Service Bulletin

No. : MZ09-022

Model: SR4002, SR5002, SR4003, SR5003, SR6003

Subject: Improvement of GND screws contact.

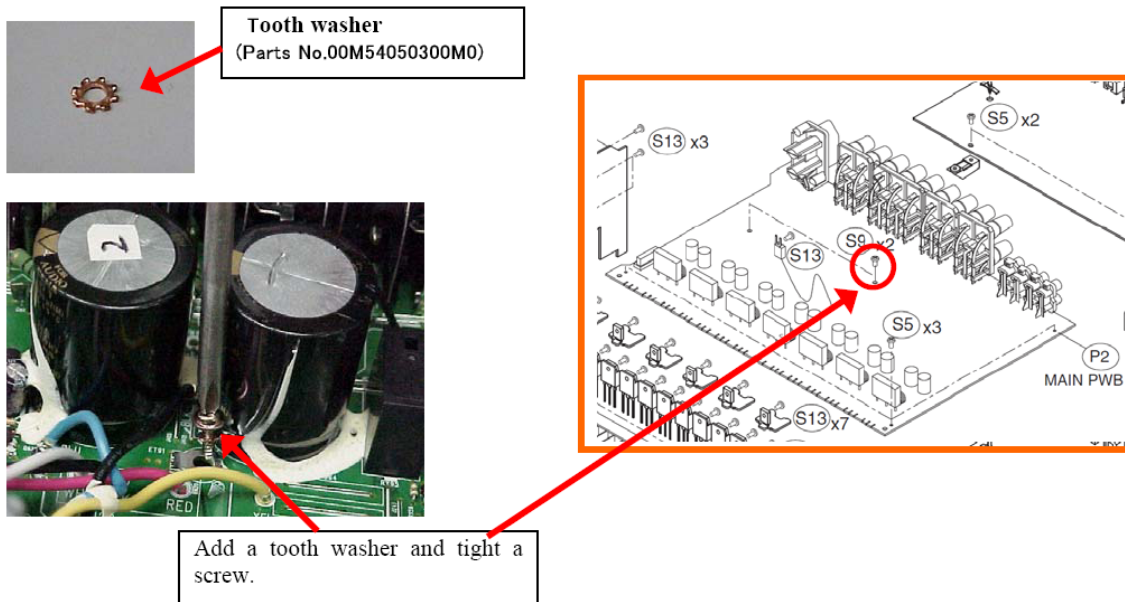
Symptom: The unit may intermittently go into protection (Fast blinking Standby LED). No problems are found in the output circuitry and heat is not an issue. The ground point screw on a Main board can loosen during transportation, handling etc., and the contact to ground may become intermittent causing a protect situation.

Solution: Add a toothed washer between the ground point screw and PCB land located on a Main board (see diagram below) and then tighten the screw.
